8/09/2012

## **ADDENDUM # 001**

### **Project: 591 Lafond**

Owner: St. Paul HRA (NSP)

**BACK STAIR SECTION & PORCH SECTIONS**

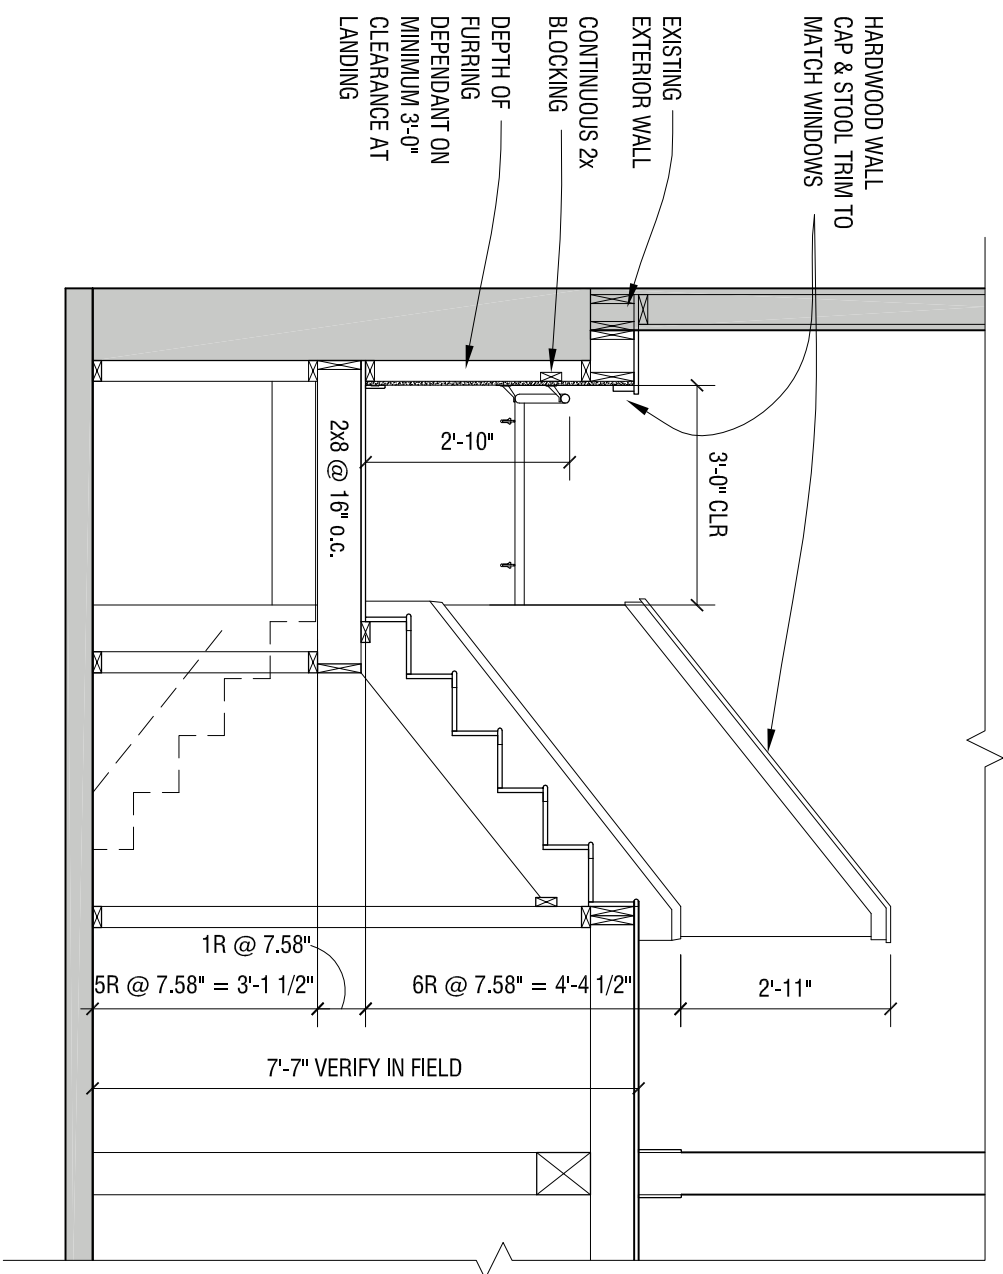
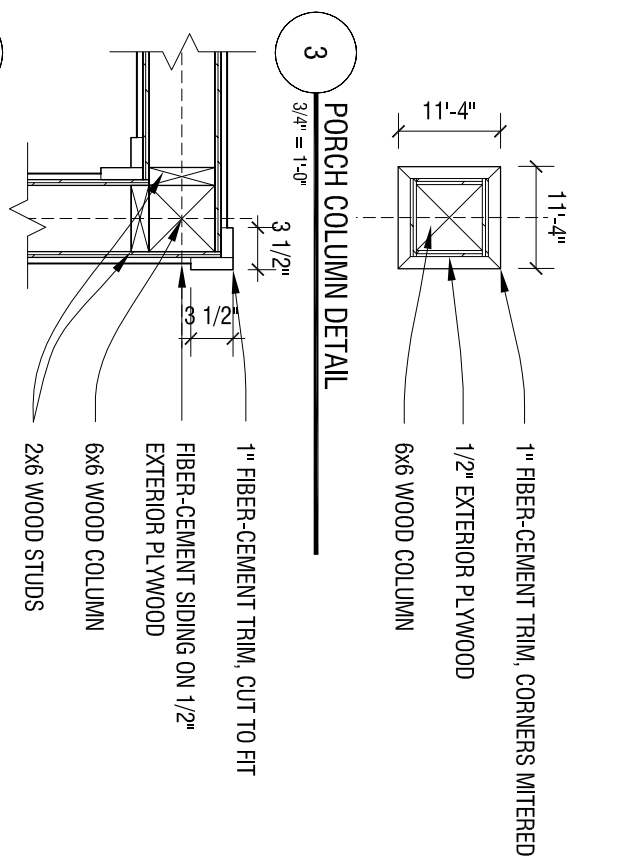
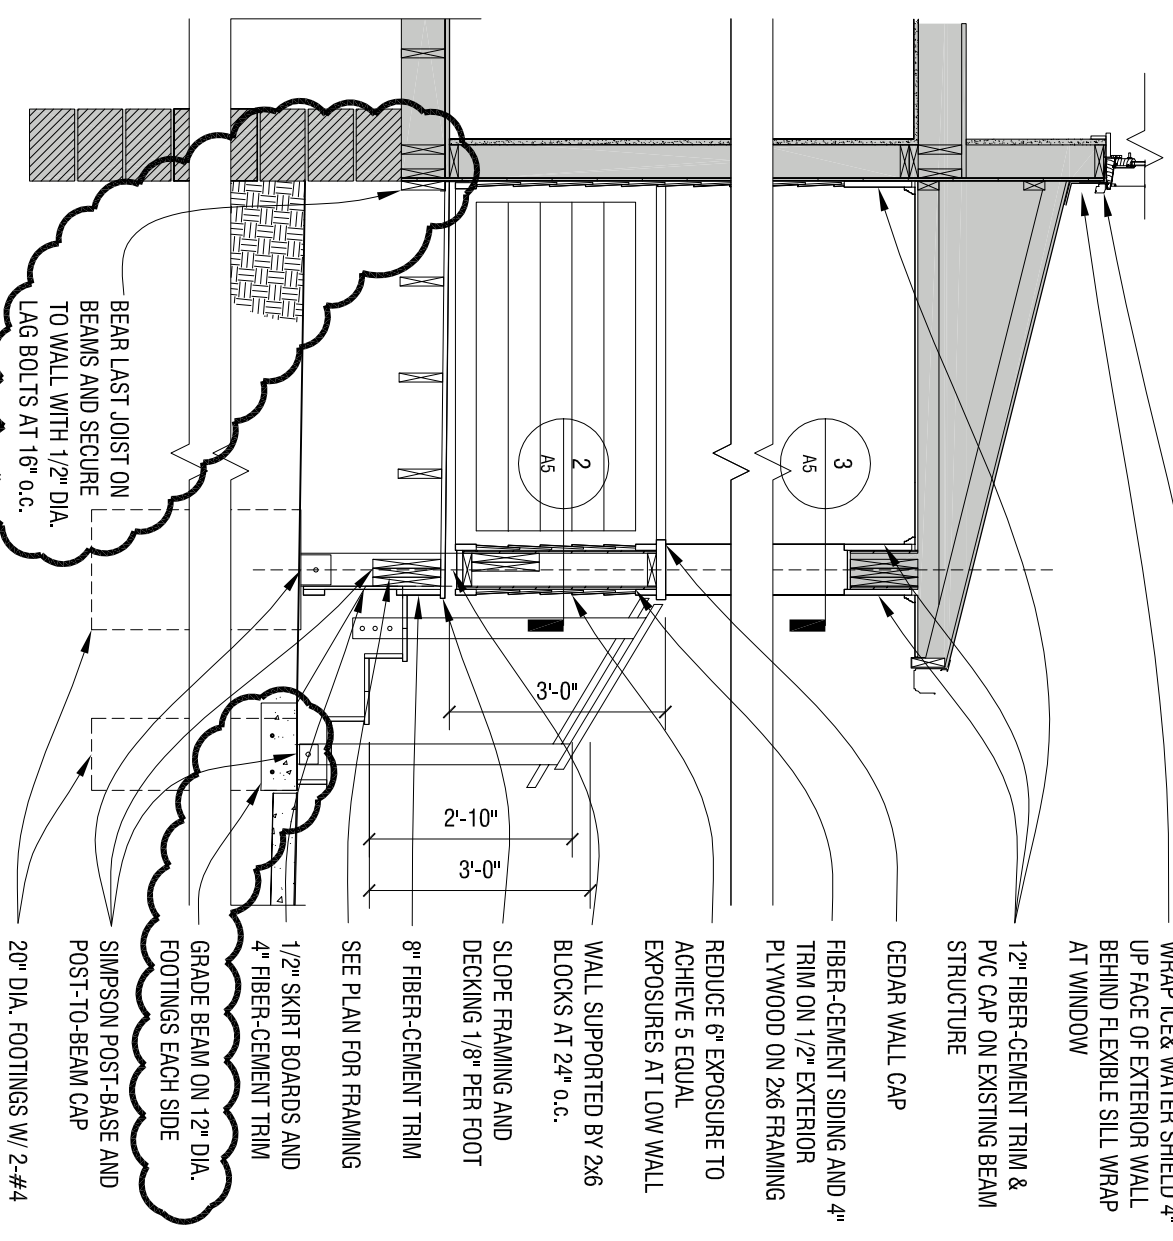
1. Sheet A1
  1. Add General Note #5: Demolition indicated by dashed lines.
2. Sheet A4
  1. Change drawings 1D and 2D to show a side splash at countertop.
3. Sheet A5
  1. This sheet reissued in its entirety.
4. Sheet A6
  1. Window Schedule, Change Window type D to read “Glass block” in lieu of “Casement.”
  2. Door Schedule, Change all door heights to 6’-8”.
5. Add Survey to drawing set. See attached.
